**REMARKS**

Appln. No. 10/611,912  
Amdt. dated October 26, 2004  
Reply to Office Action of July 26, 2004

**AMENDMENTS TO THE DRAWINGS**

FIG. 3

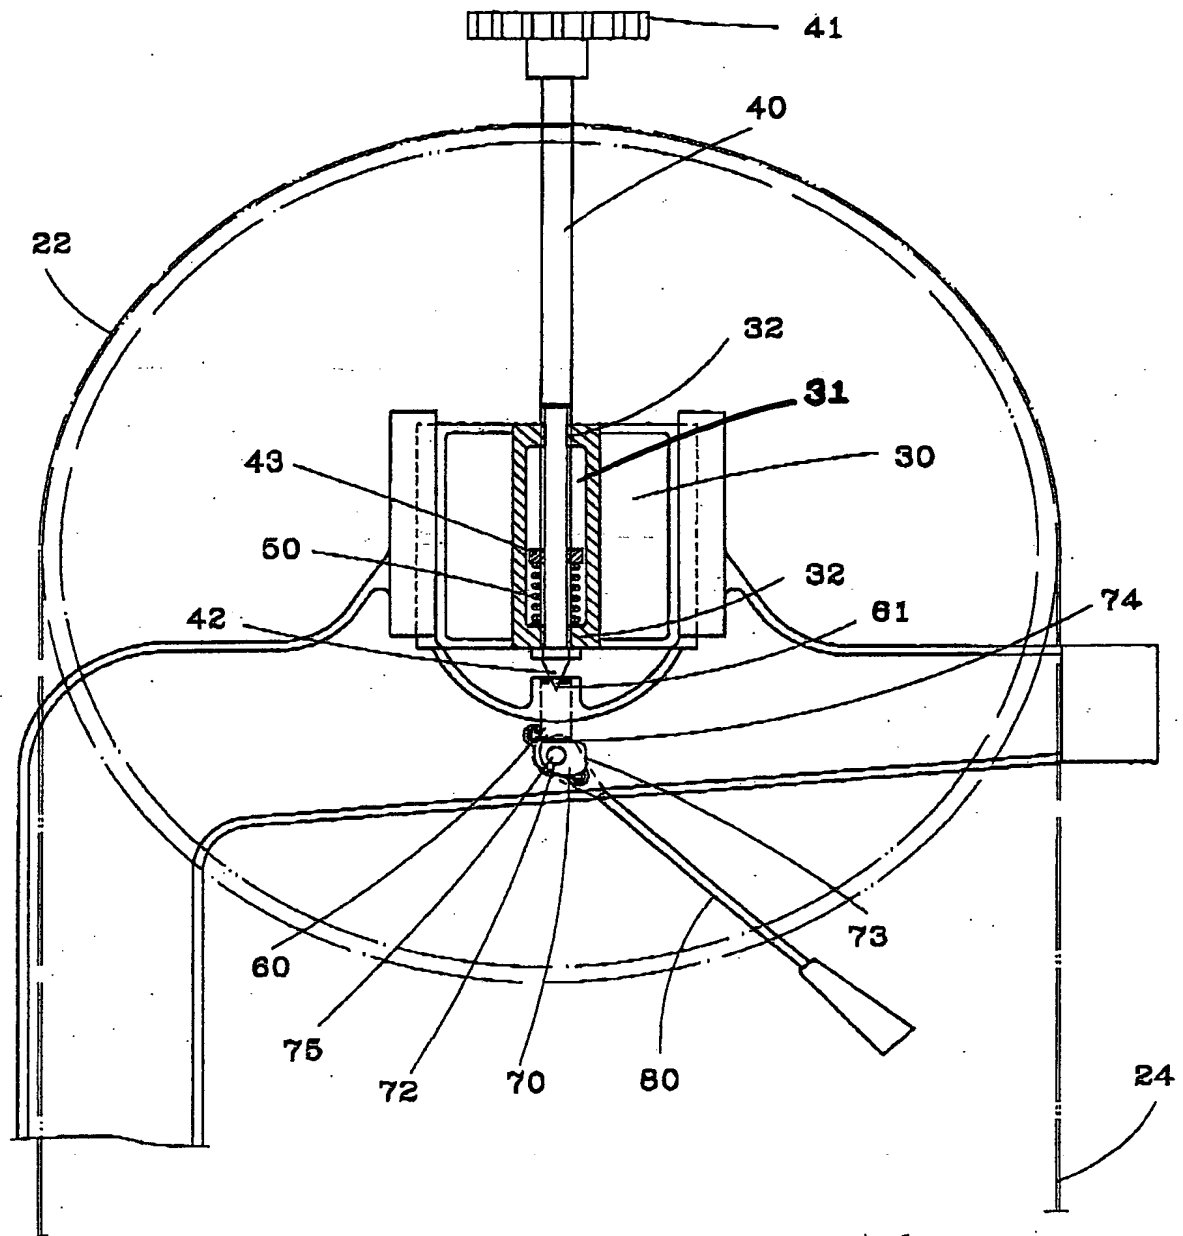
In response to the Examiner's objection to the drawings, Applicant has enclosed an amended Fig. 3 showing element 31.

The attached drawing sheet includes Figure 3 only.  
This sheet replaces the original sheet including Figure 3 in  
which previously omitted element 31 has been added.
